U.S. NUCLEAR REGULATORY COMMISSION

Report No. 50-295/OLS-86-06

Facility Name: Zion Nuclear Power Plant

ATTACHMENT 1

FIGURE 5.1

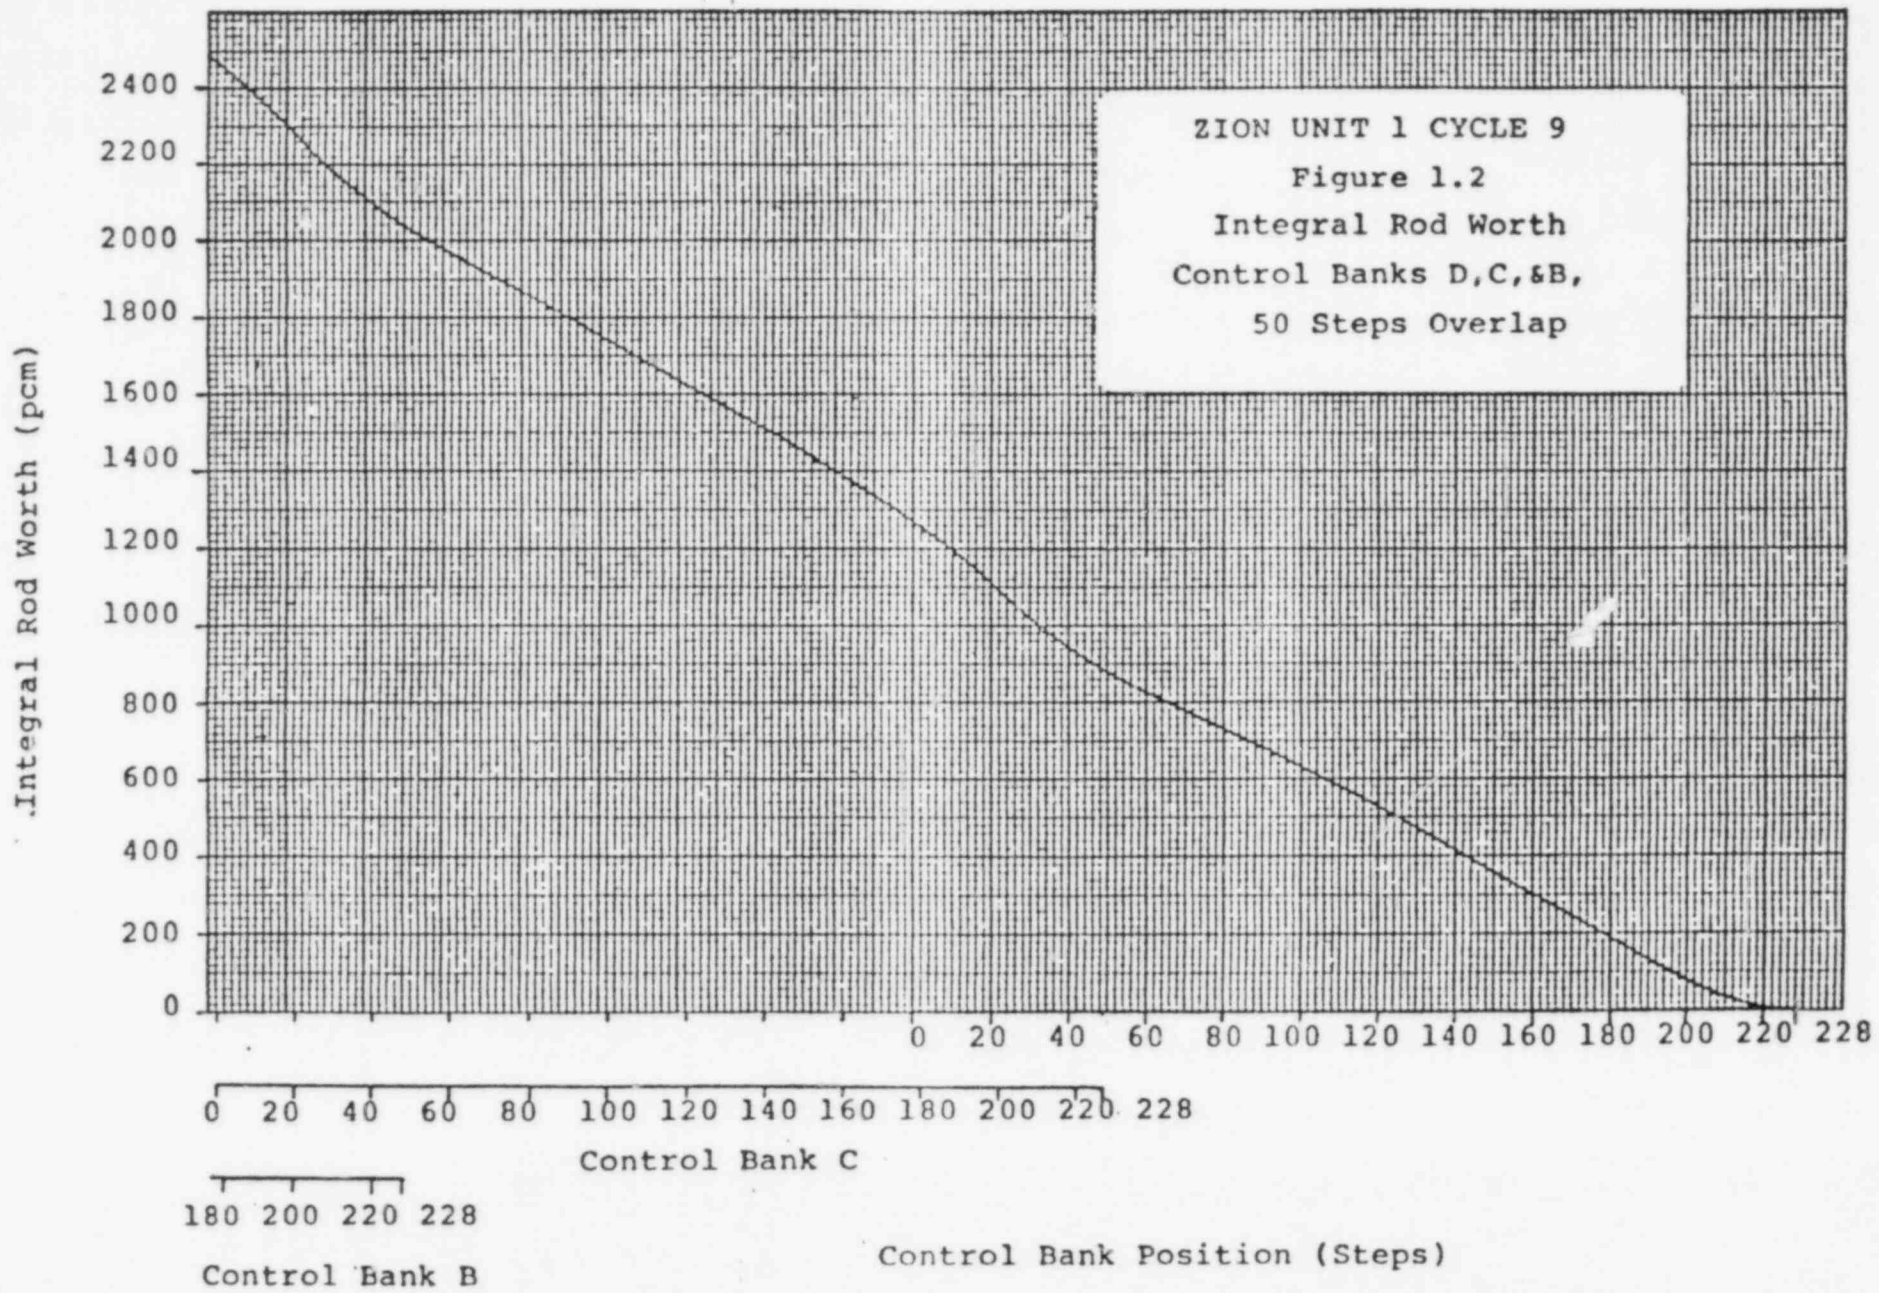
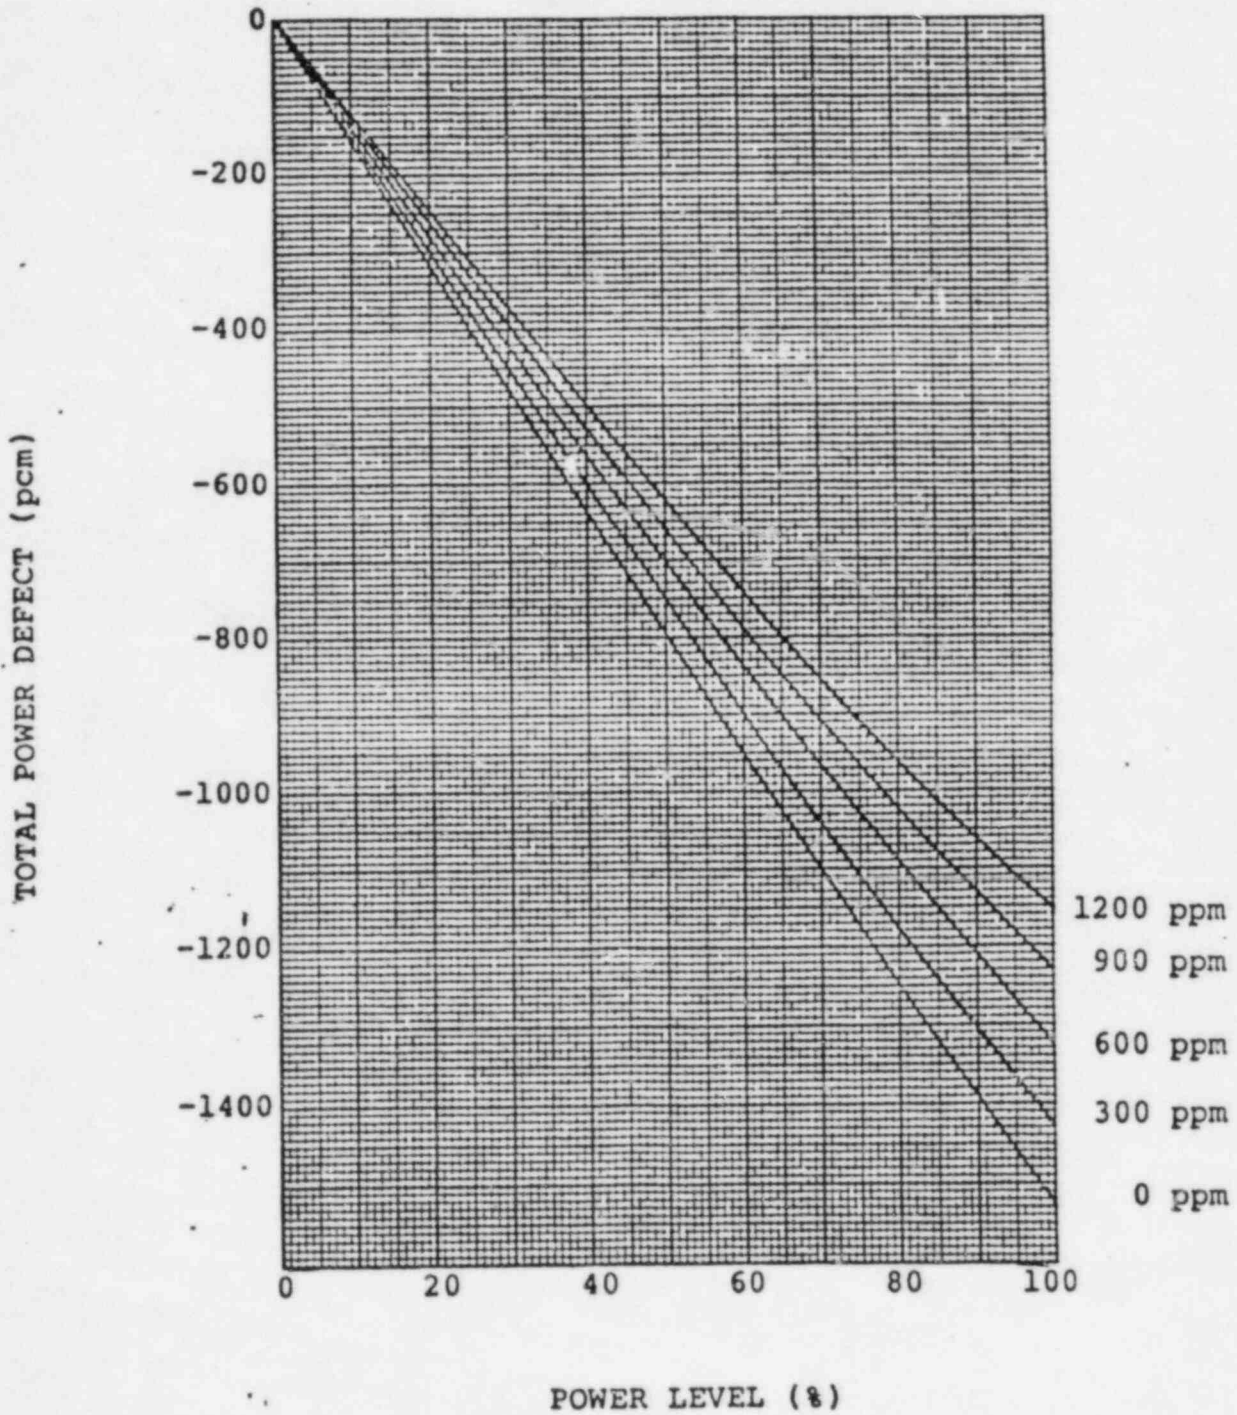
Question 5.02a

Same comment and resolution as Question 1.02a.

FIGURE 1.1

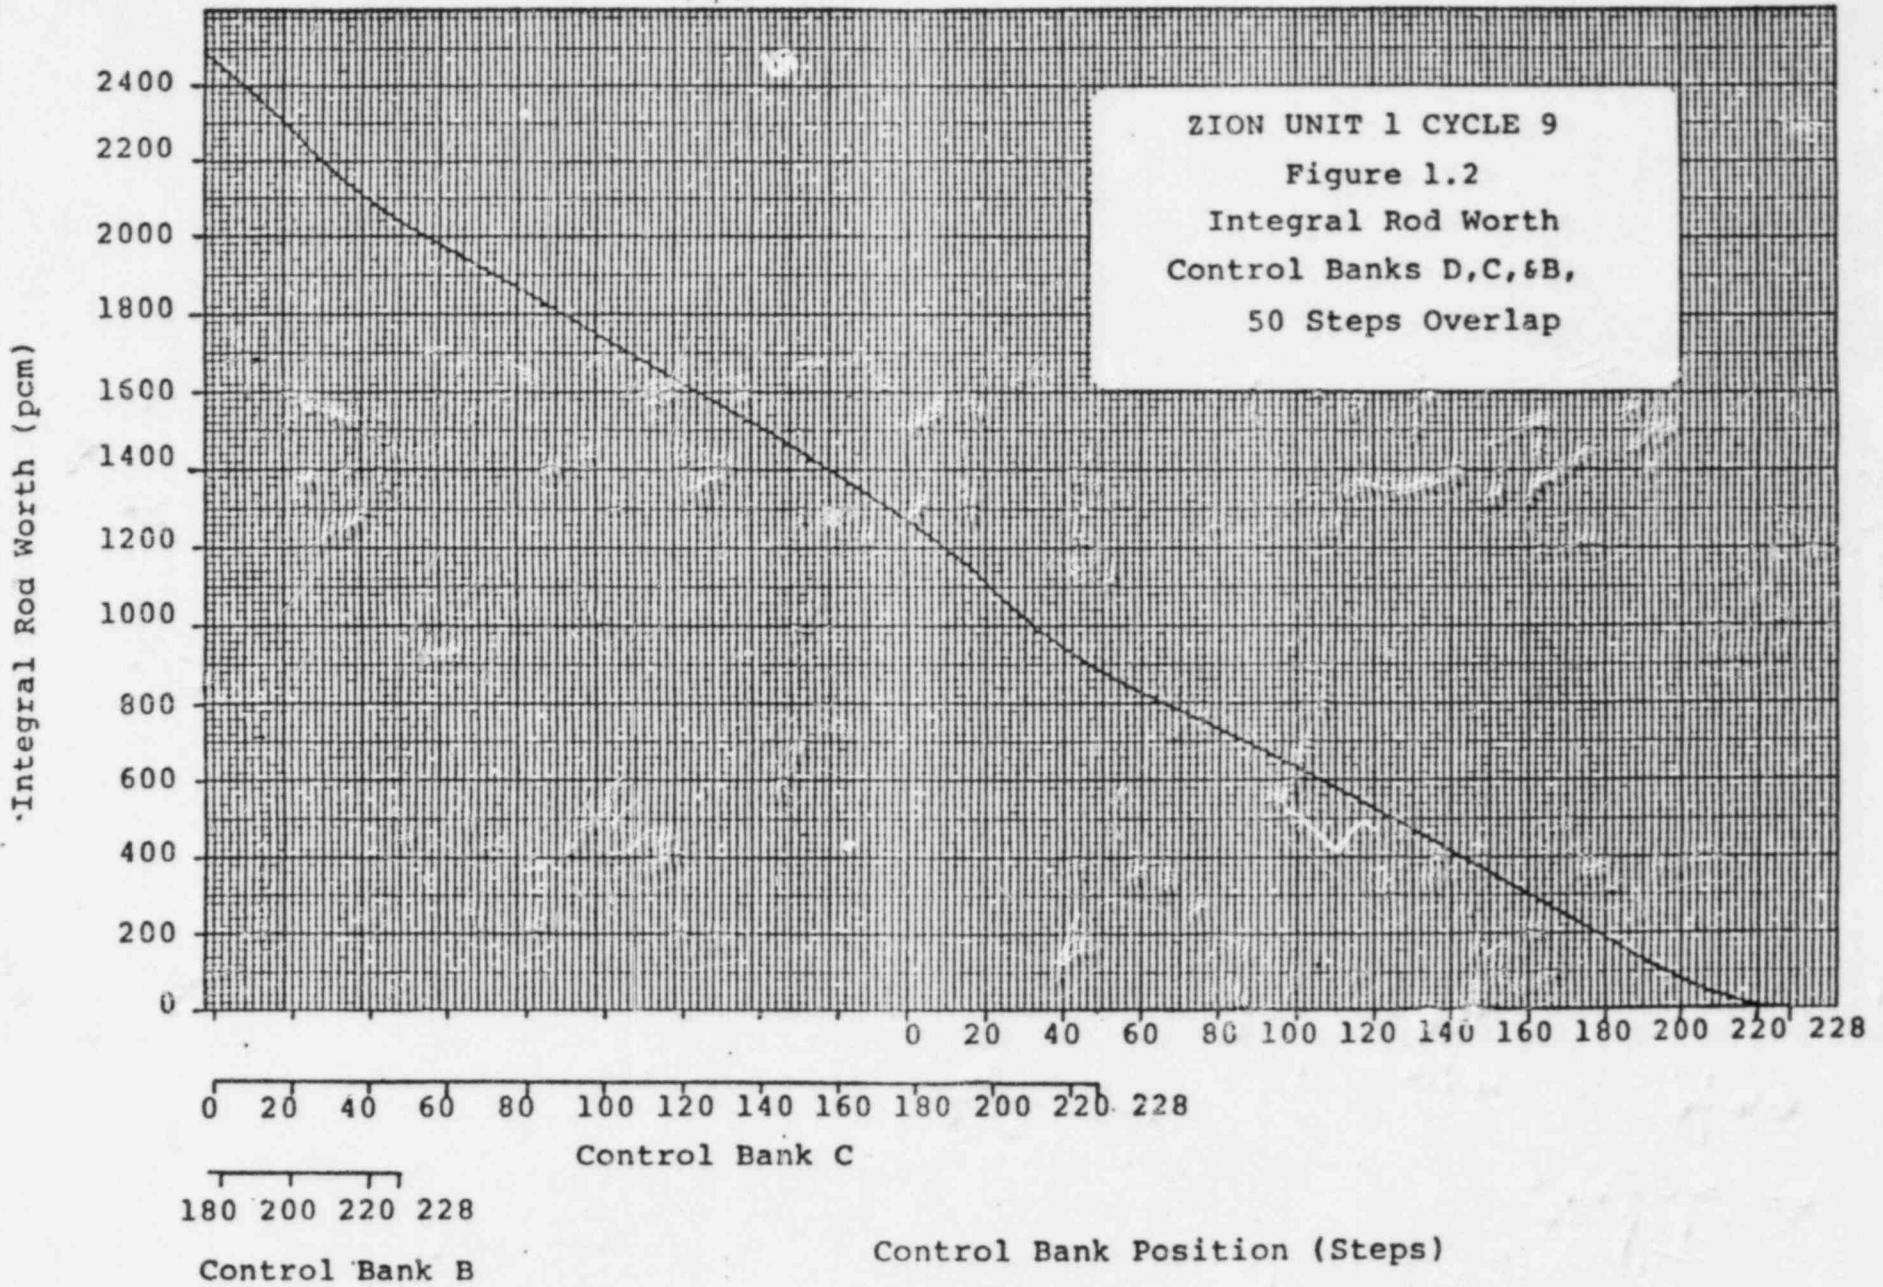
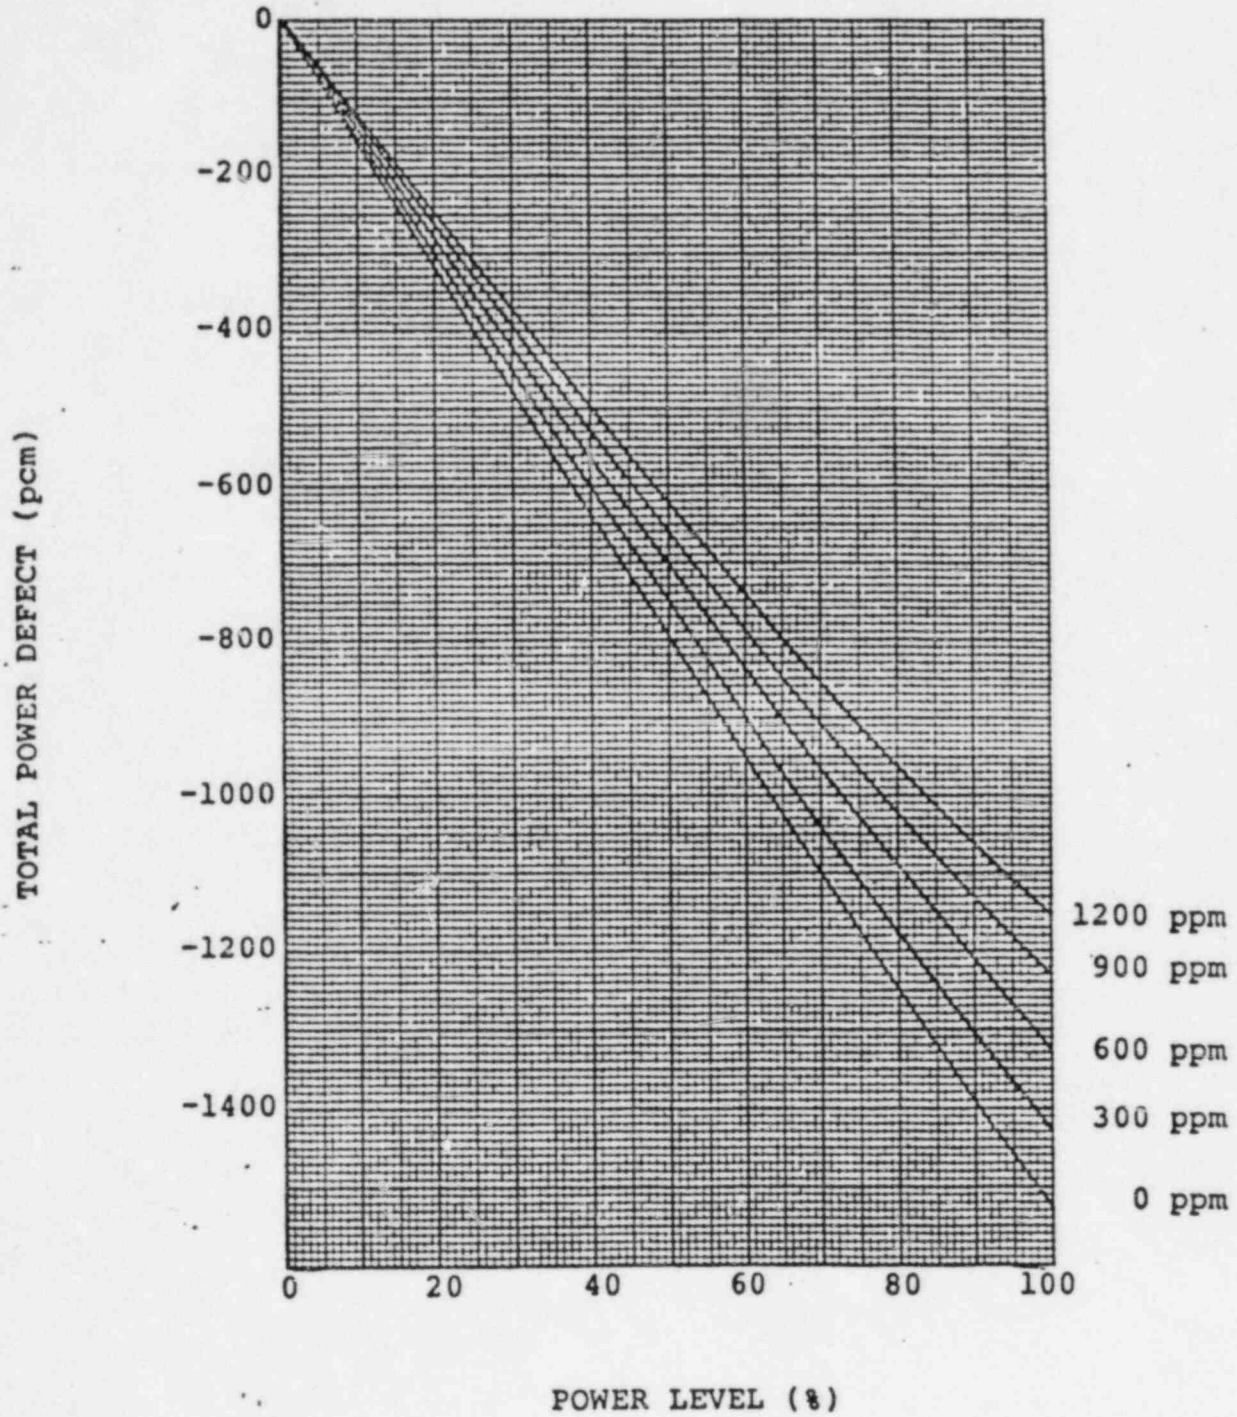
Question 1.02a

Comment: The acceptable range of values from Figures 1.1, 1.2 seem a little narrow, especially considering how an "early error" can compound through the solution.

Resolution: Comment noted. Initial range was sufficient. No change.
